**Subject: Field Safety Notice** – Uninstallation of Model 2868 software from Model 3120 ZOOM™ programmers. (Boston Scientific Field Action Reference: 92822246-FA)

Uninstall Model 2868 Software from Model 3120 ZOOM Programmers

**Figure 1.** Message that displays when a Boston Scientific TV defibrillator is interrogated by a 3120 ZOOM programmer if 2868 software is uninstalled.

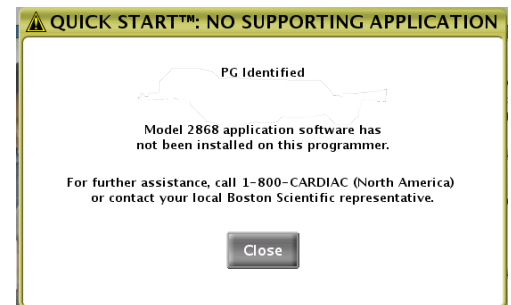
Model 2868 software facilitates interrogation of transvenous defibrillators<sup>1</sup> by the 3120 ZOOM programmer. For Model 3300 LATITUDE the programmers, an enhanced version of TV defibrillator software was developed that upgrades firmware of each TV defibrillator as needed during the first interrogation. When 2868 software is uninstalled from the 3120 ZOOM programmer, it can no longer interrogate TV defibrillators. If a user attempts to interrogate a device without applicable software, a message is displayed (Figure 1) to notify the user that software has been uninstalled on the programmer. To determine if a programmer has 2868 software, select “About” on the programmer screen and review the list of software applications installed. Please note that 2868 software is the only outdated application on the 3120 ZOOM programmer.

**Recommendations:** Please work with your local Boston Scientific sales professional to identify/uninstall Model 2868 software from affected 3120 ZOOM programmers at your facility.
